MONTGOMERY COUNTY PLANNING DEPARTMENT
THE MARYLAND-NATIONAL CAPITAL PARK AND PLANNING COMMISSION

MEMORANDUM

SUBJECT: Special Exception Modification Request (CBA-864-B: Potomac Swim Club)

Staff Recommendation: Denial. The applicant is proposing to modify the existing community swimming pool special exception to include an outdoor exercise area, increased office space, an additional tennis court, a temporary tennis bubble, and light fixtures for evening tennis play. Although elements of the proposed improvements satisfy the statutory standards for approval, the planned size of the tennis bubble would be out of scale with nearby residential homes and clearly in view of the homes located to the northwest and southeast sides of the site. The special exception is not on an isolated site. It is surrounded by one-family detached residential homes. The tennis bubble would have a footprint of approximately 18,600 square feet and present an unacceptable visual feature in the neighborhood.

Landscape and Lighting Plan (November 17, 2008)

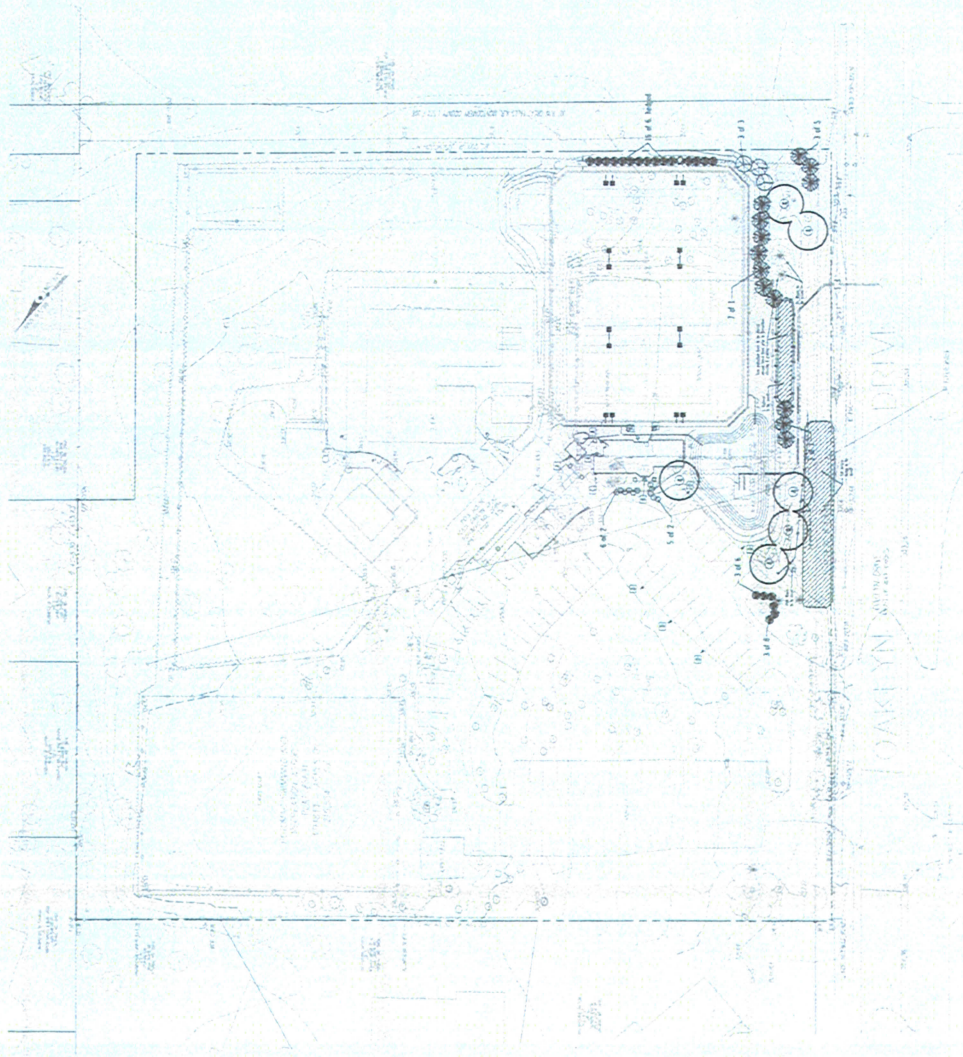
Staff Analysis: The lighting plan shows several different light fixtures to be used on-site for evening play. All lights are proposed to be placed on the lower courts and lower parking area, both near Oaklyn Drive. The lighting plan includes standard box lighting, with shields and decorative lighting in the parking area nearest to Oaklyn Drive. The box light fixtures will be located on the tennis courts. There are ten single-headed and eight double-headed fixtures within the tennis court area and all lights poles will be a maximum of 20-feet (from grade to top of the pole). The decorative lights in the parking lot are 10 feet in height, from grade to the top of the light. Although light poles are not desirable in a residential neighborhood, given the nature of the use and the appropriate screening, it does not adversely affect the residential character of the neighborhood. Lighting at the property lines does not exceed 0.1 foot-candles. (See Attachment 10.)

Additionally, the light fixtures on the lower courts will be removed during the winter play, when the tennis bubble is inflated. Lights will hang from the interior bubble and no light is omitted, since the bubble is made from opaque materials.

lighting as set forth in the site plan. However, there is a concern with the bulk and size of the proposed tennis bubble. The applicant will retain most of the landscaping that now exists, but intends to modify the landscape to include lighting and some additional row Leyland Cypress along the southeast side of the bubble. The proposed row of Leyland Cypress, along the southeast portion of the bubble, would buffer approximately 80 feet of the 120 foot long tennis bubble. The height of the trees can get up to 30 feet; however, these rapidly growing trees are prone to disease and toppling over in very wet seasons.

Potomac Swim Club Pictures

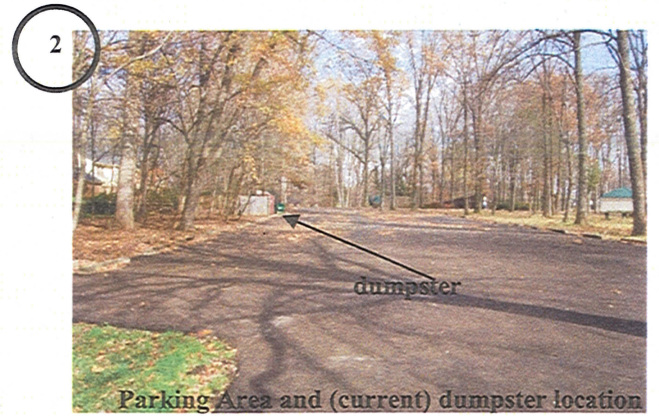
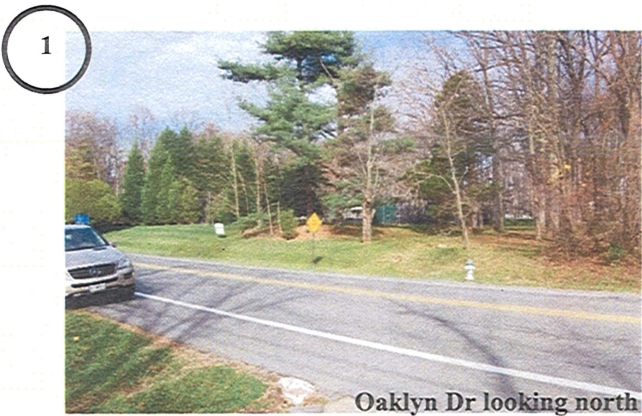
Note: Property is generally higher than Oaklyn Drive, however, is flat from east to west of property's extents. The bubble would be in the area of the bottom picture.

(Top): Generally looking east towards SF house (±192-ft from proposed courts and bubble)
(Bottom): SF house to the SW of tennis bubble.

Note: The area is heavily wooded; however, several trees will be removed and replaced by evergreens. The existing courts are to be removed and relocated 13-feet from the side yard setback. Currently, the courts are 80-feet from the side yard.

Potomac Swim Club Cross Sections (November 17, 2008)

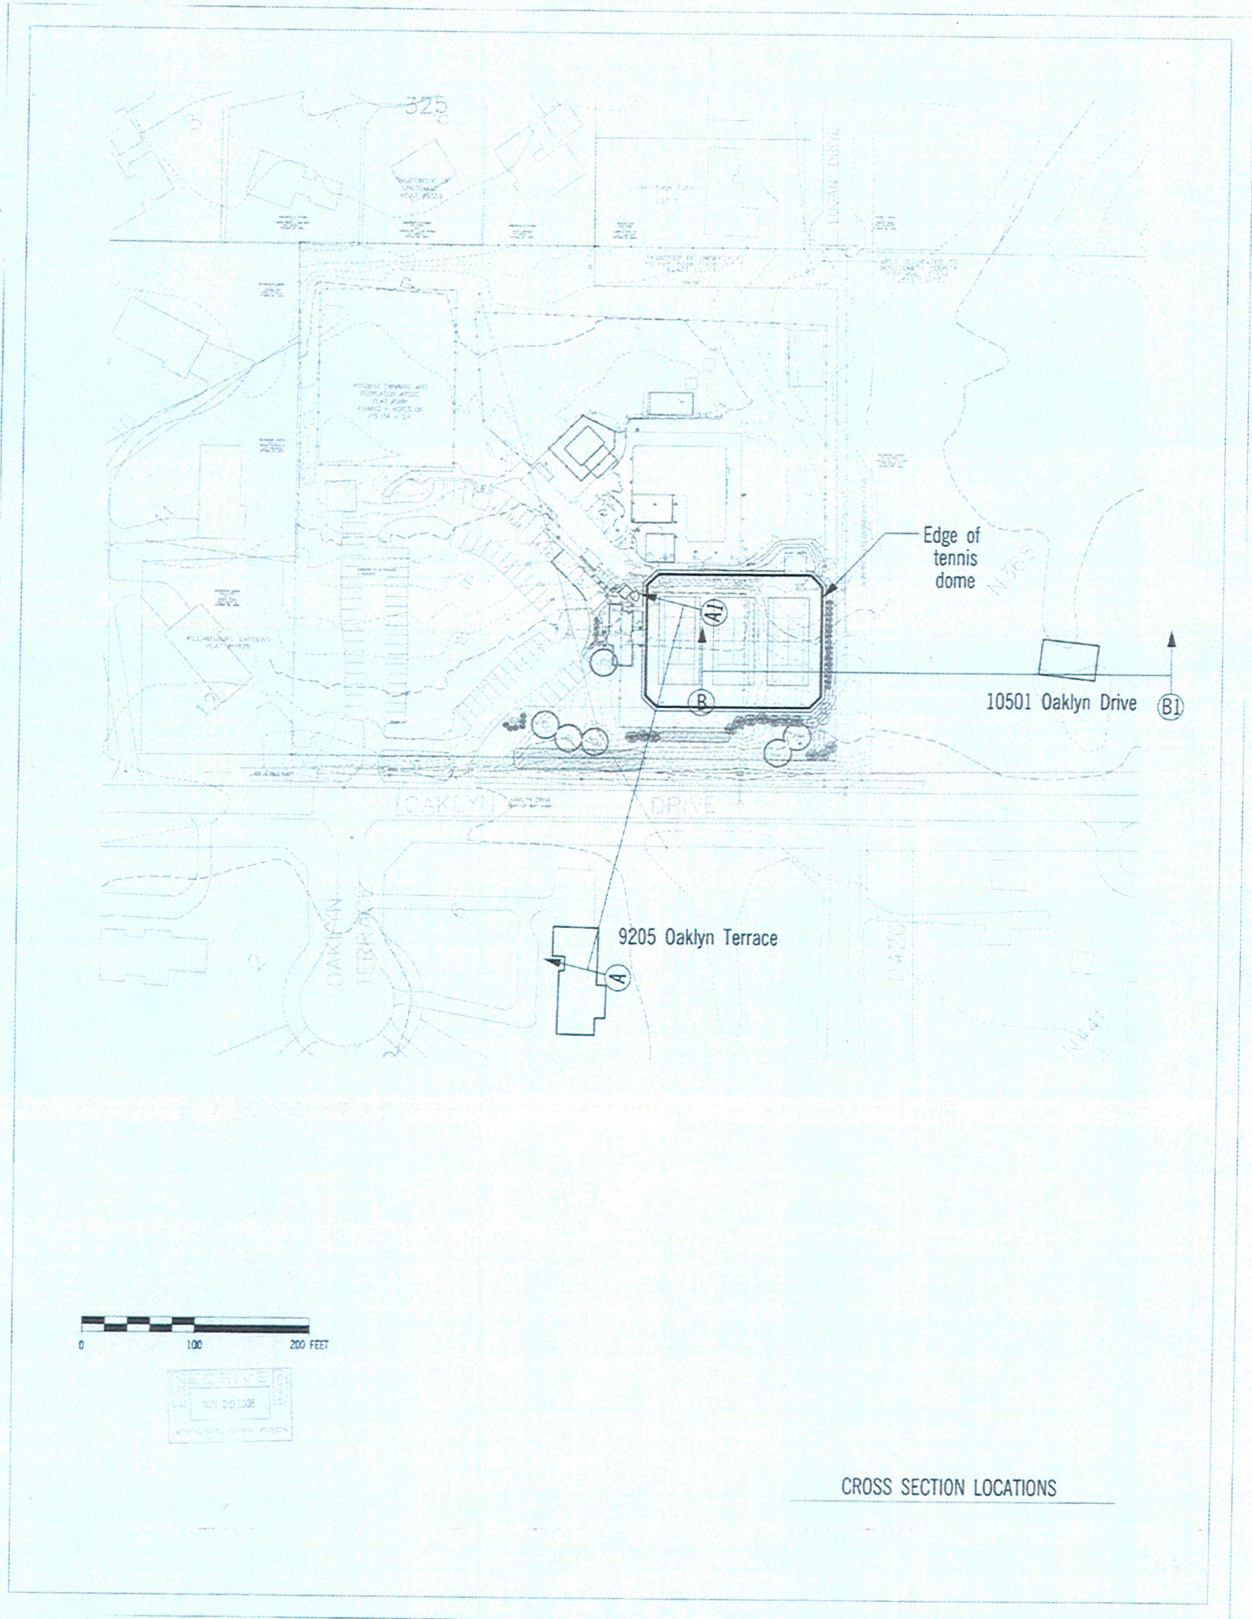
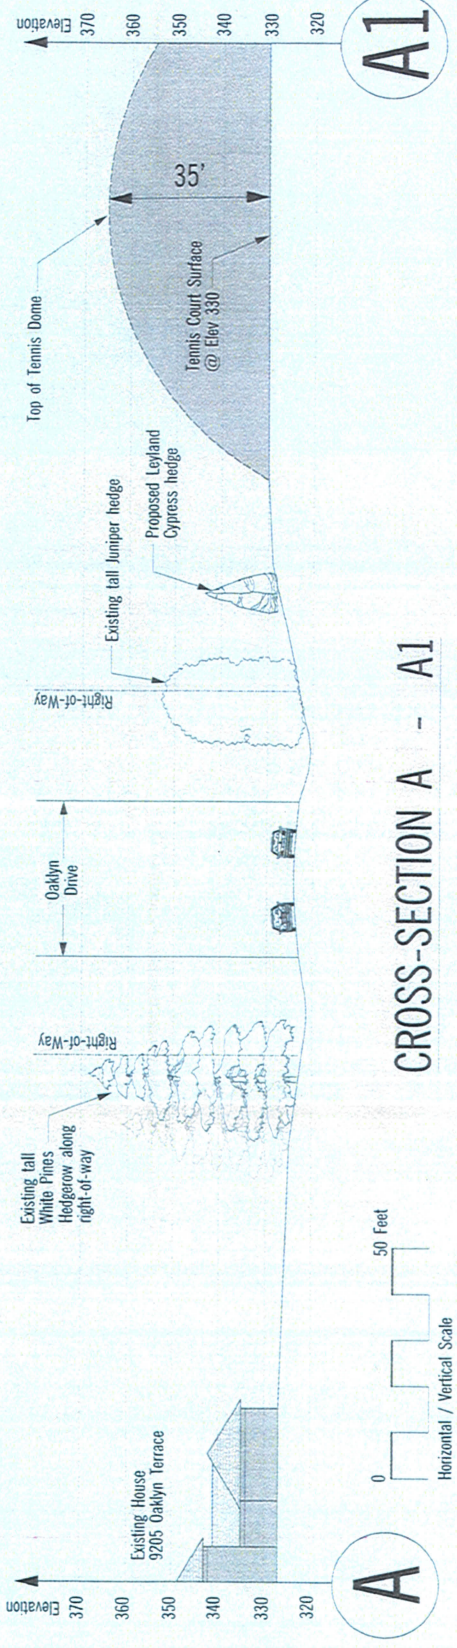
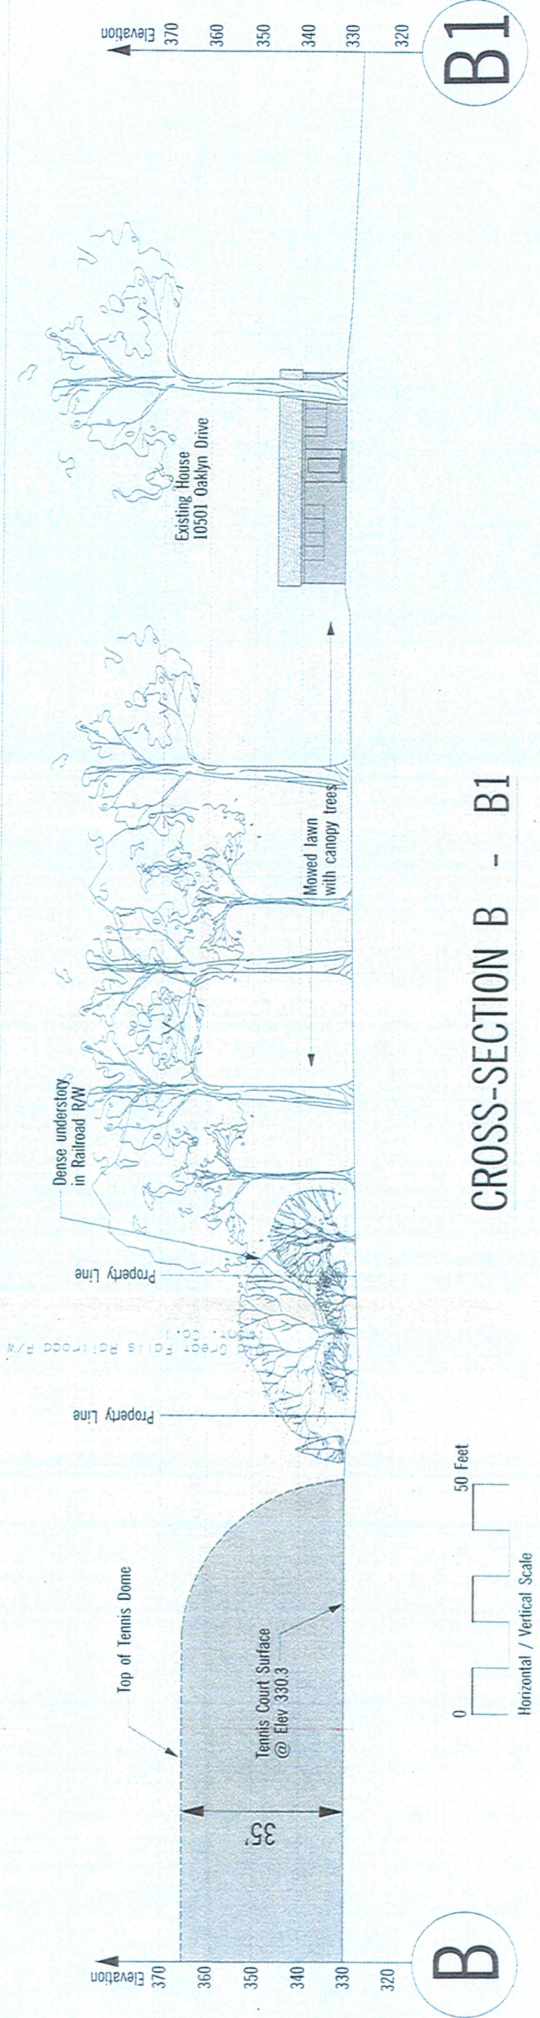
The proposed tennis bubble is incompatible with the adjoining neighborhood by reason of its bulk and character. The cross sections submitted on November 21, 2008 are the first graphics to truly depict the potential visual effect of the structure. At approximately

18,600 square feet in area and 35 feet in height, this opaque structure would dwarf the adjacent dwelling house at 10501 Oaklyn Drive, some 192 feet distant. The one story dwelling house has a footprint (scaled) of approximately 1500 square feet. The proposed landscaping would not sufficiently mitigate the effects of such a large monolithic structure.
